Edgemont at Bethesda II, Sketch Plan No. 320180030 and Preliminary Plan Amendment No. 11984058A

Completed: 1/19/18

SKETCH PLAN NO. 320180030

PRELIMINARY PLAN AMENDMENT 11984058A

Figure 2-Proposed Sketch Plan

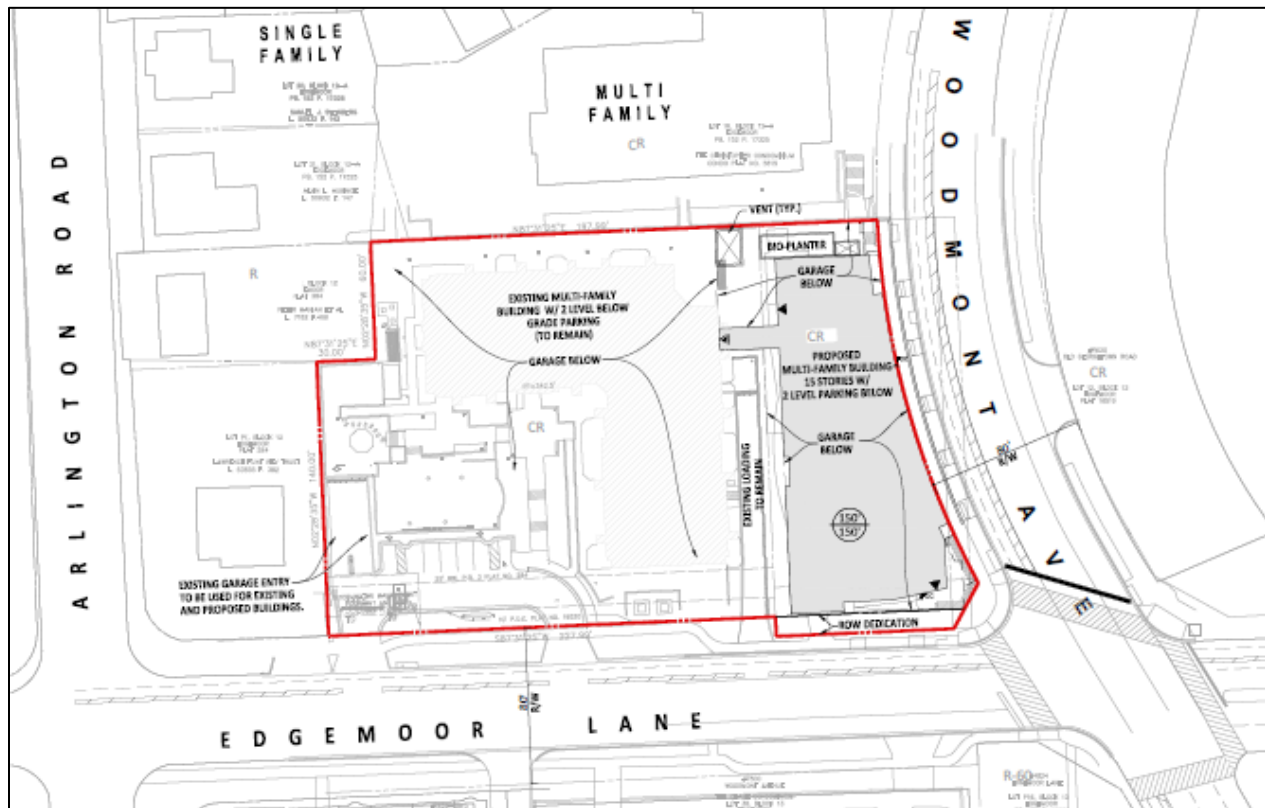
1. Exceptional Design Points: The design could get to the requested 20 points at Site Plan, though it is not there yet and should incorporate the following recommendations:

- b. Provide one accent material and show restraint on other materials because there is so much articulation.
3. Provide more indoor/outdoor relationship from the ground floor uses to the sidewalk. Part of the Woodmont Avenue façade could be residential unit entries to activate the sidewalk in addition to the amenity spaces.
